SERVICE BULLETIN No

16-2

PRODUCTION CHANGE

SUBJECT: SPRINGS FOR OIL PRESSURE RELIEF VALVE
VEHICLES: SEE TABLE

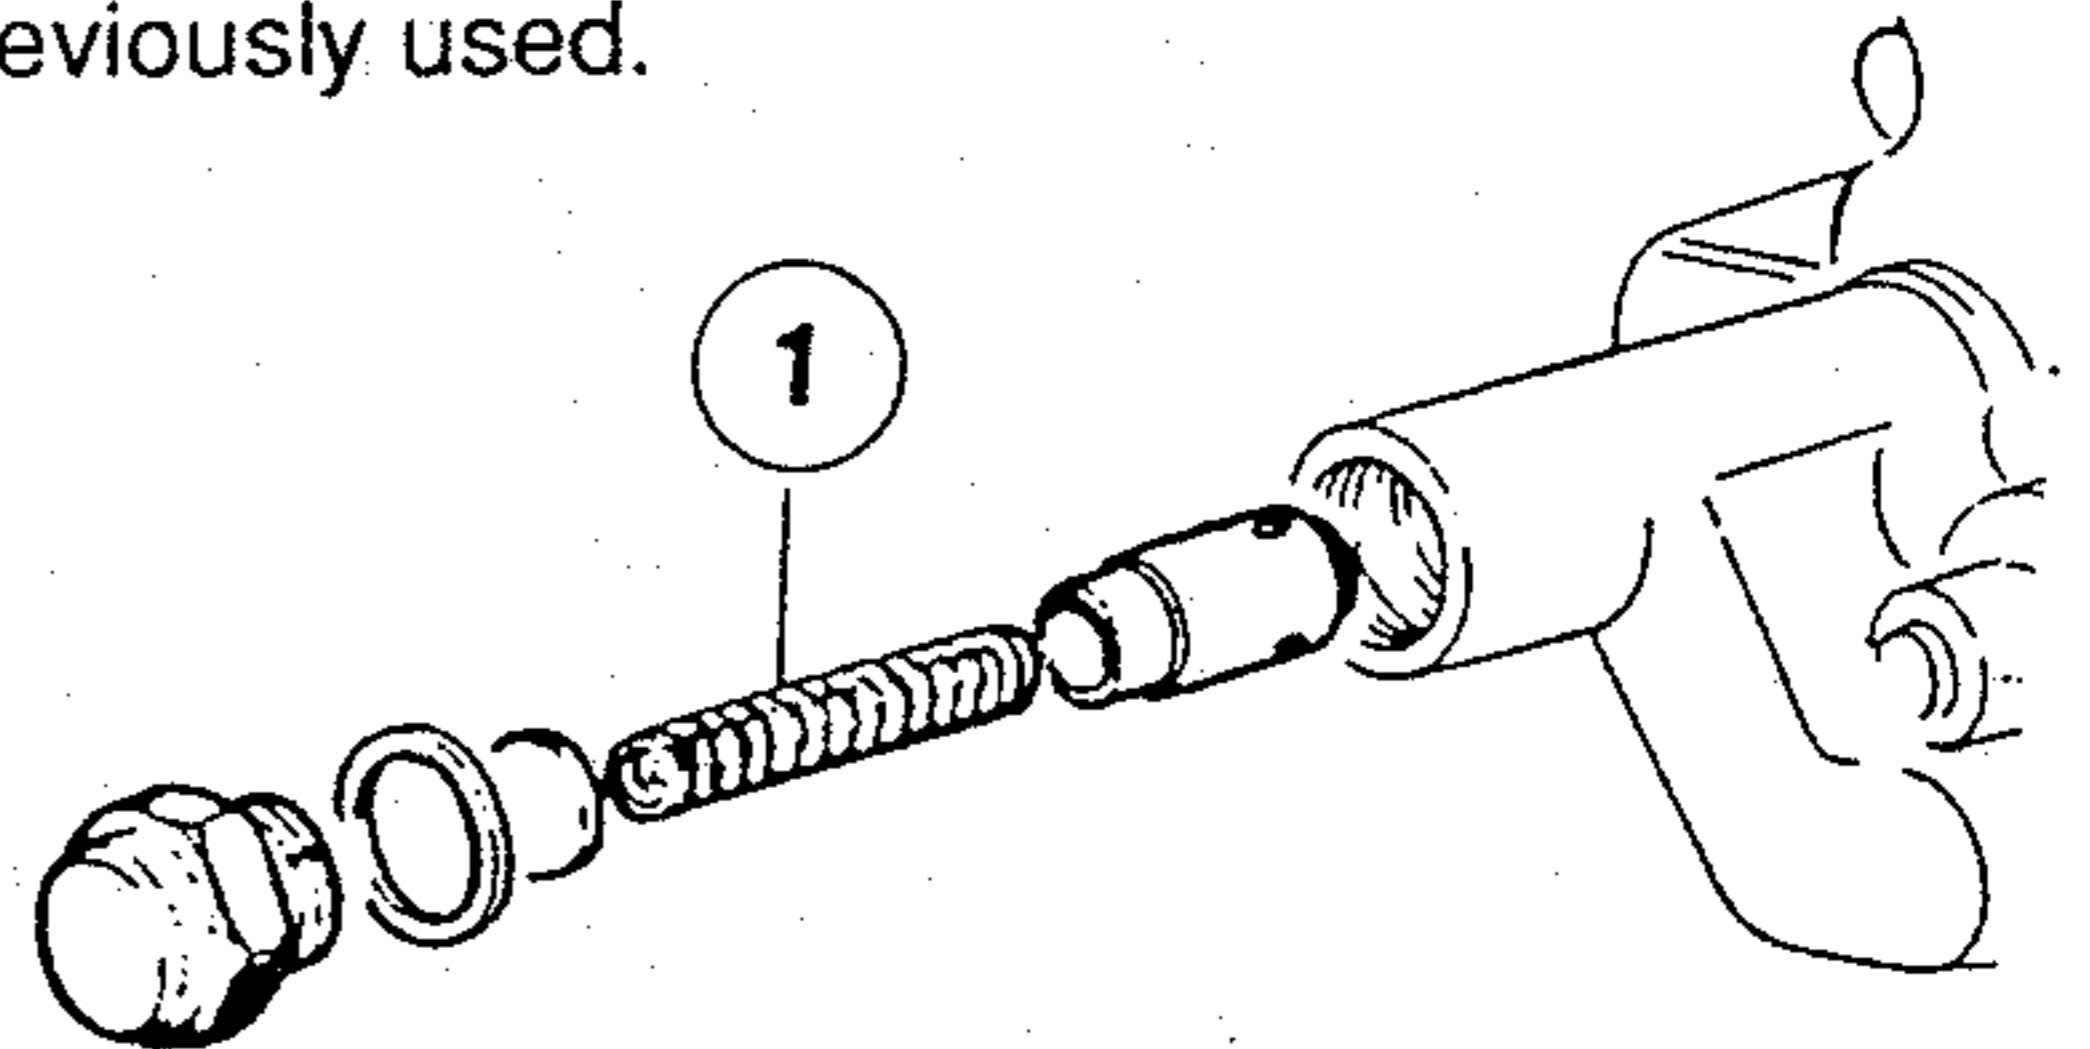
A new spring for oil pressure relief valve has been introduced; the new spring is more flexible and slightly shorter than the spring previously used.

REPLACED PARTS			NEW PARTS		
ref. fig.	Part Number	Description	ref. fig.	Part Number	Description
1	106900	Spring (76 mm long)	1	133550	Spring (72mm long)

In case of replacement, use only the new spring.
